**RE: Anthea – 4<sup>th</sup> and Granite NW  
330 Granite NW  
Request Permanent C.O. - Accepted  
Engineers Stamp Date 9/12/14 (J14D171)  
Certification Dated: 8/28/15**

PROJECT TITLE: ANTHEA – 4<sup>th</sup> at GRANITE NW ZONE MAP: J-14/D171  
DRB#: 14-DRB-70196 EPC#: NA WORK ORDER#: NA

**Re: Anthea – 4<sup>th</sup> at Granite  
Grading and Drainage Plan  
Engineer's Stamp Date 9-12-14 (J14D171)**

**SUBJECT: ANTHEA – 4<sup>TH</sup> AT GRANITE (J14/D171)**  
**14 DRB 70196**  
**PROJECT 1010103**

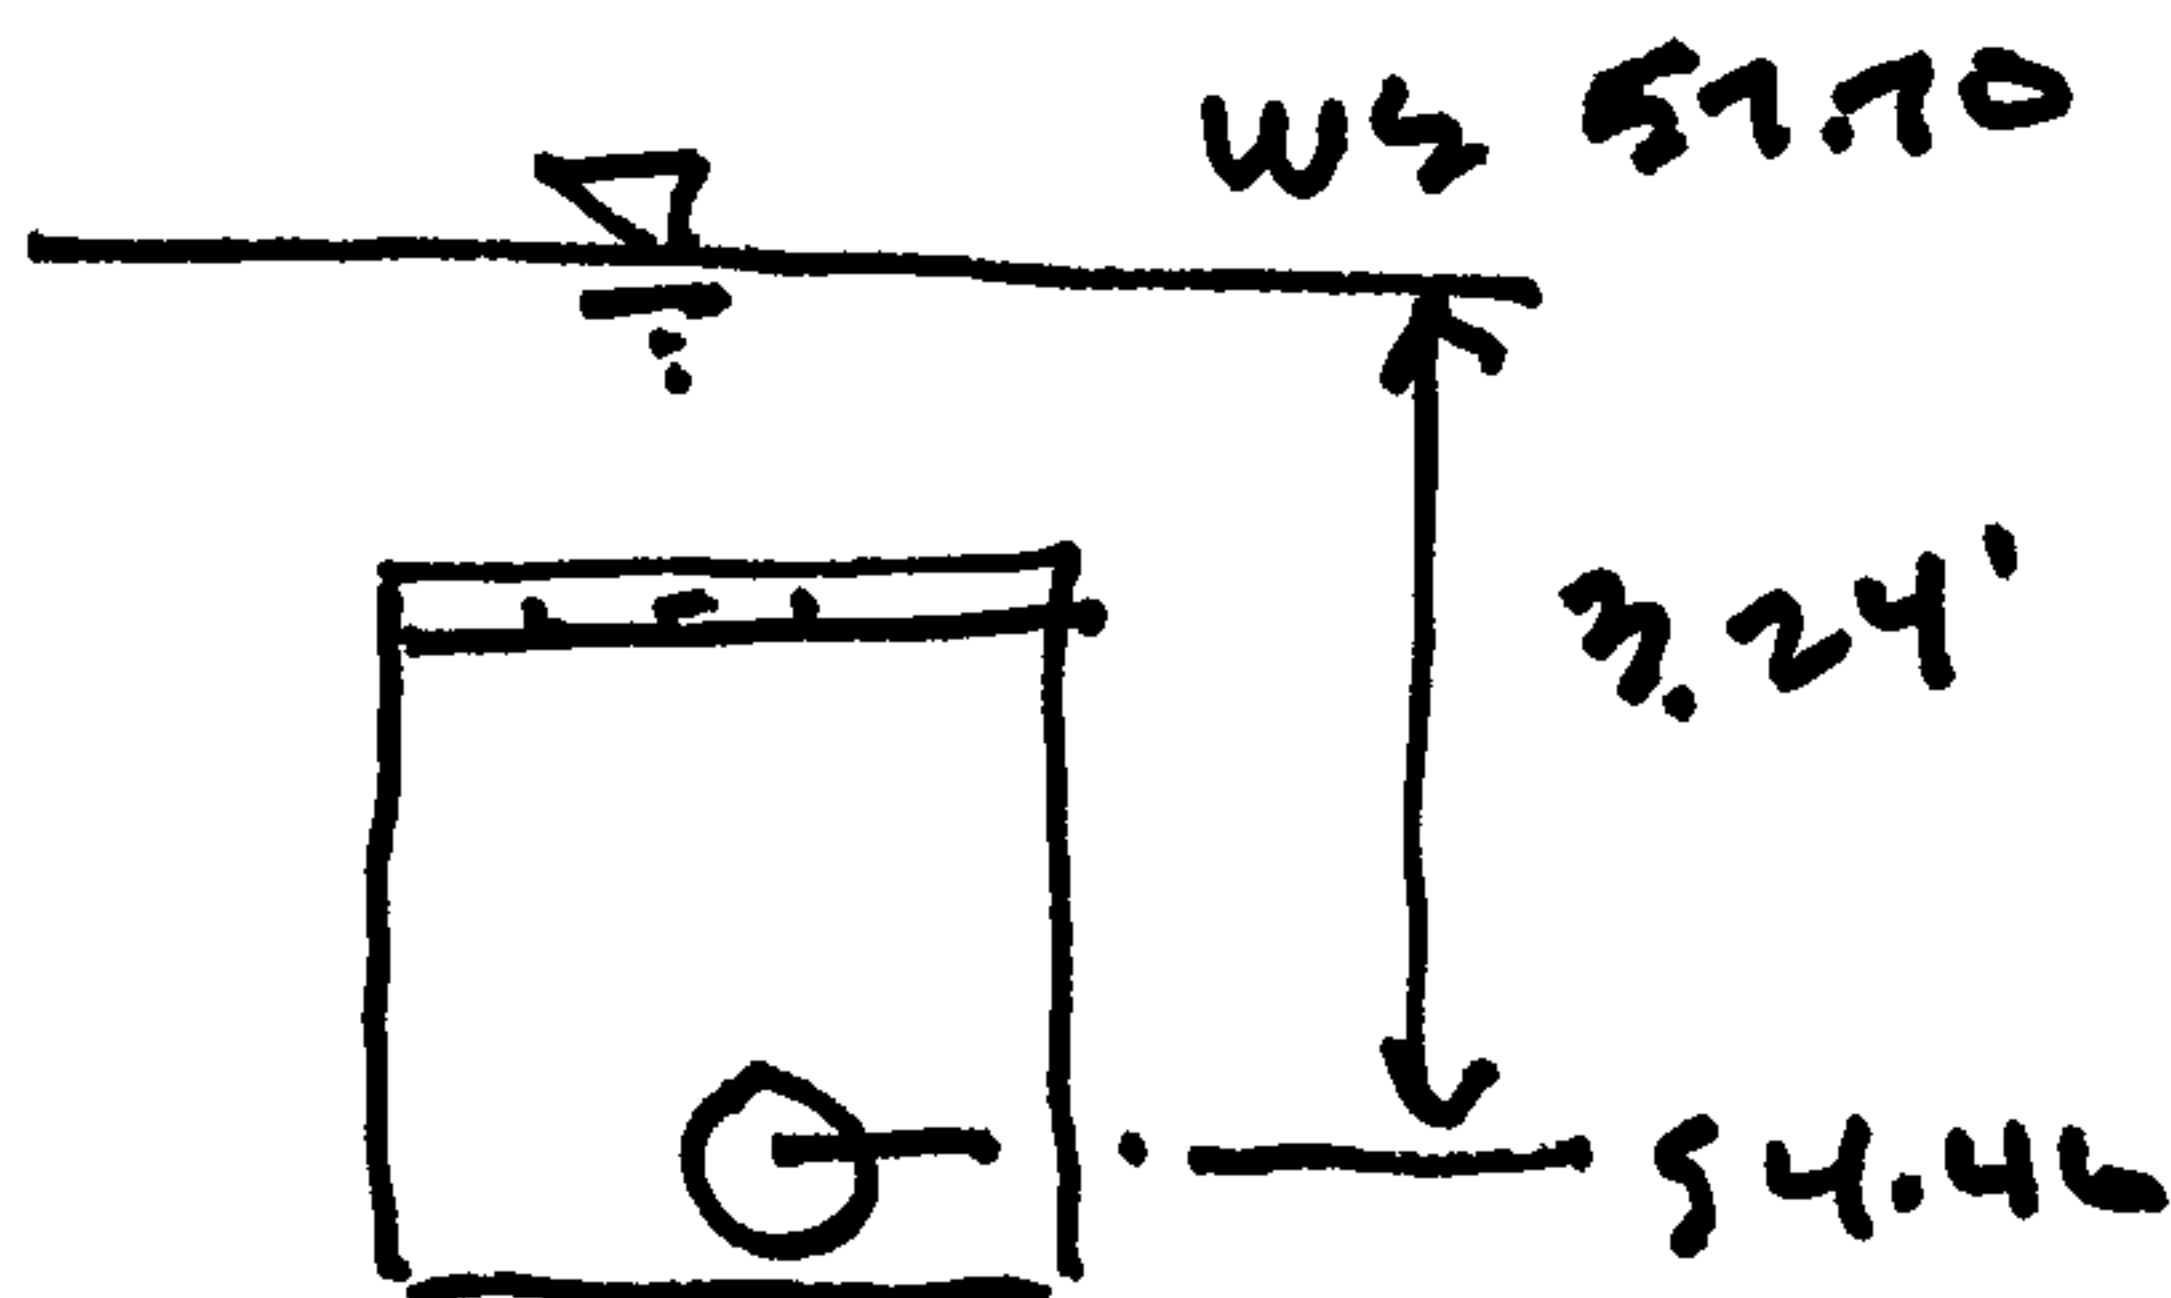
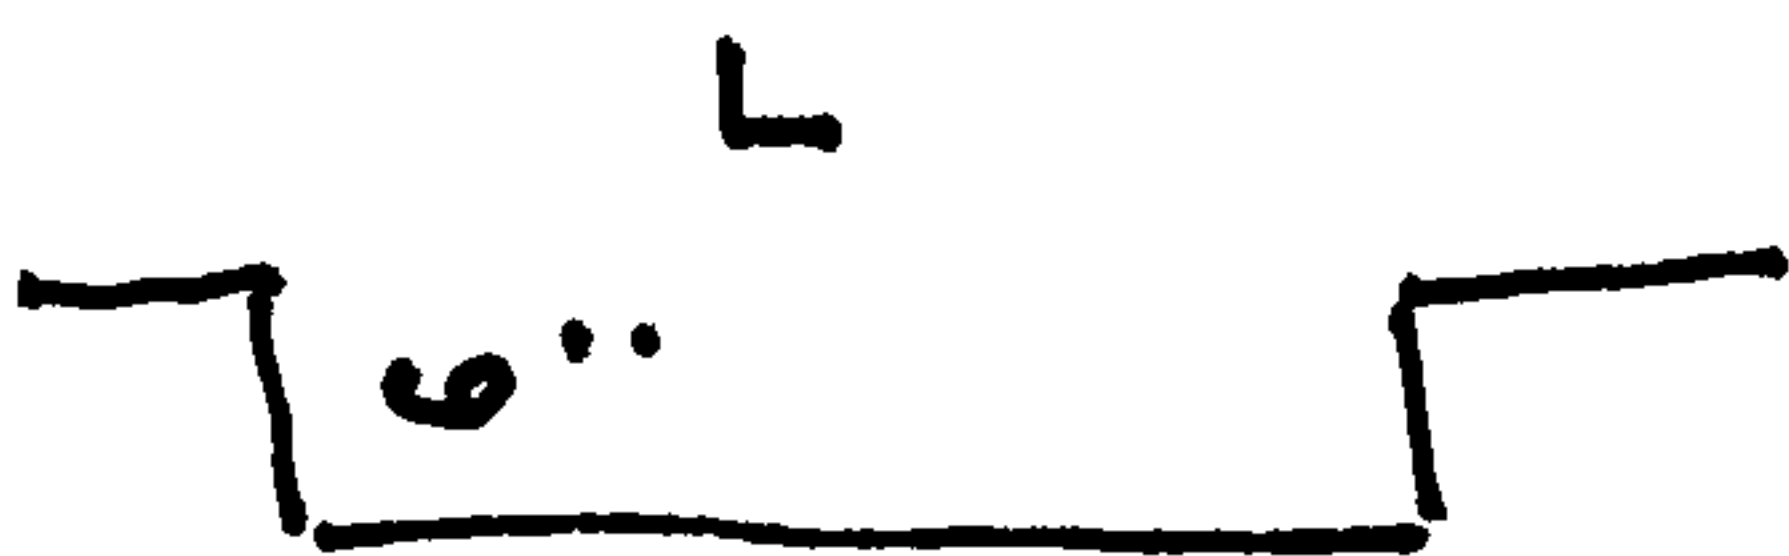
⇒ 300 CF SHORT FALL, HOWEVER, PLAN MEETS  
ORDINANCE TO MAXIMUM EXTENT  
TECHNICALLY FEASIBLE.

$\Rightarrow \underline{Q = 4.8 \text{ CFS}} > Q_{\text{ALLOW}} \quad \# \text{ SYSTEM LIMITED TO } 2.19 \text{ CFS BY PIPE FLOW}$

PROVIDE OVERFLOW SPILLWAY FOR  
FLOW SHOULD OUTLET FALL
